Septic Repair

**ON-SITE SEWAGE DISPOSAL SYSTEM
HOWARD COUNTY HEALTH DEPARTMENT
BUREAU OF ENVIRONMENTAL HEALTH**

ADDRESS: 2698 Jennings Chapel Road

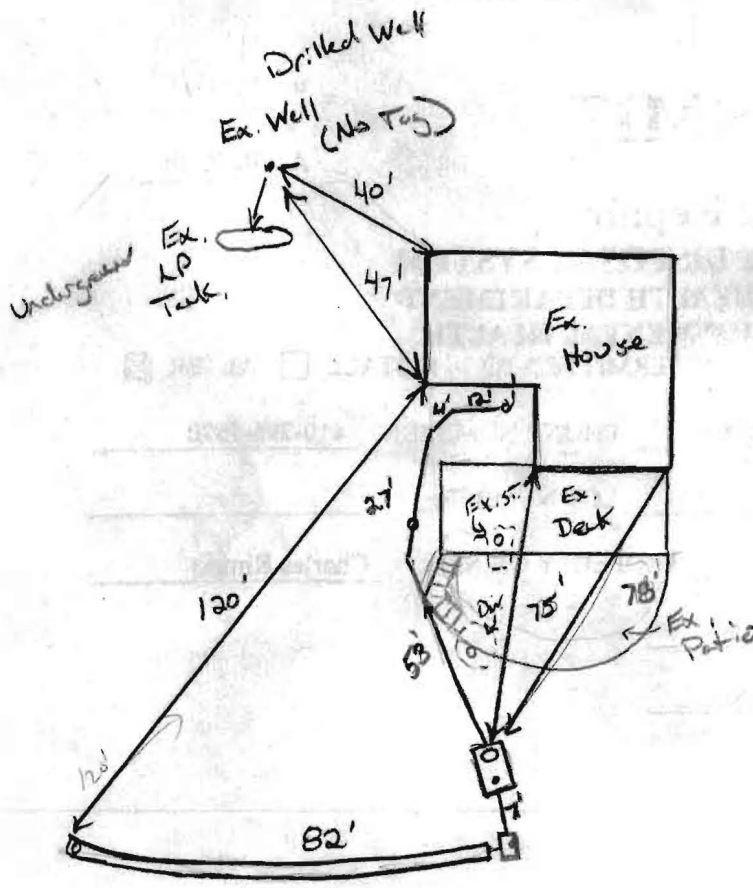
9/23/13 Contour shot in field. OK to install 1x82' trench just above parcel hole A. set new s.t. just above new D box in open area. Plenty room to rework system as needed. (pud)

9/26/13 system complete. Ex Dry well and S.T. pumped. Needs to be collapsed. (pud) 10/1/13 Ex. S.T. and Dry well pumped/collapsed.
